Invitation for Bid No. 2022-054

Chain Link Fencing Storage Area(s)

ADDENDUM No. 1

ISSUE DATE: April 22, 2022

Storage Area #1 – Left Side of Arena Looking Out

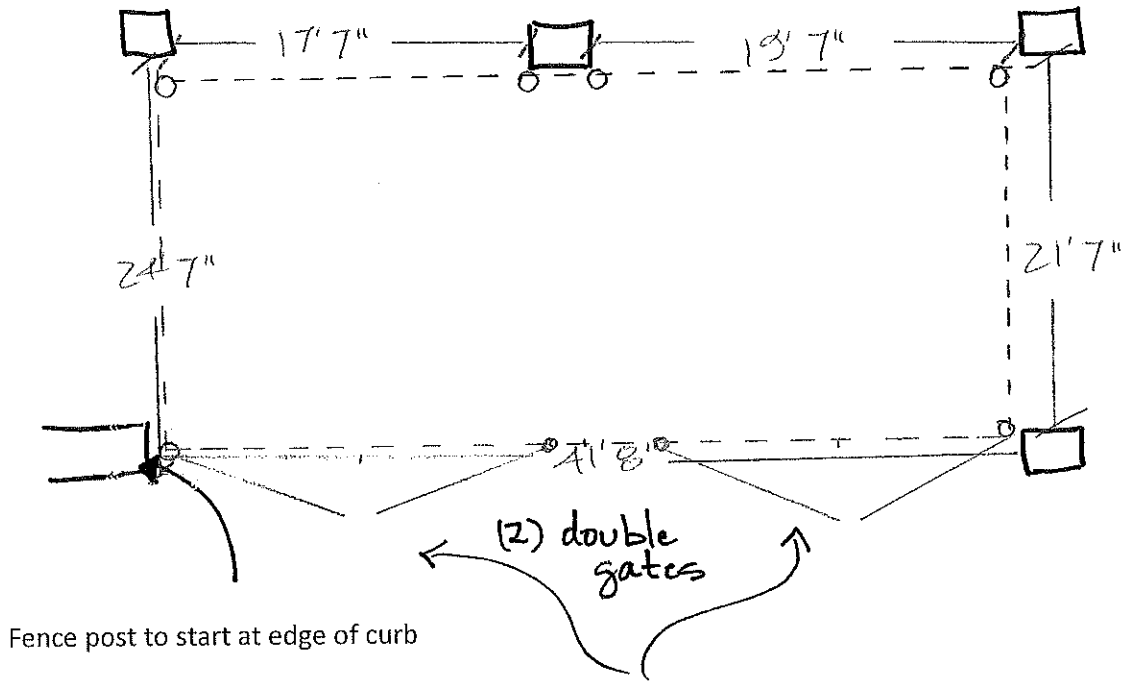
- Dimensions are shown to reflect the approximate distance between existing columns
- Fence, post and gate to be installed in concrete slab along existing control joint, shown as a dashed line -----

The Special Events Center at Jessie Helms Park
Storage Area #2 – Right Side of Arena Looking Out

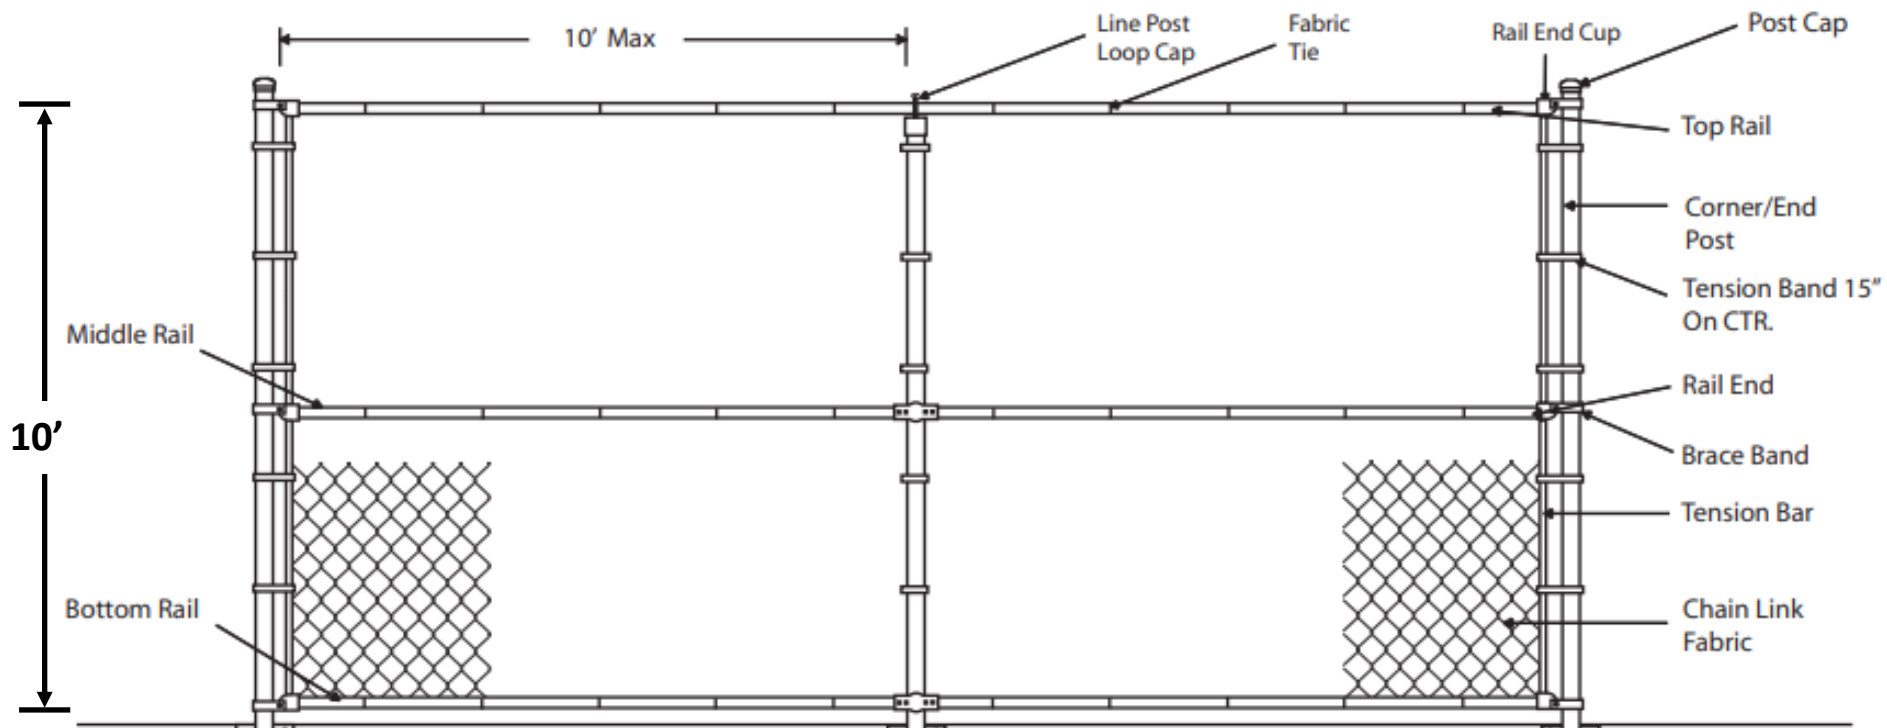
- Dimensions are shown to reflect the approximate distance between existing columns
- Fence, post and gate to be installed in concrete slab along existing control joint, shown as a dashed line -----
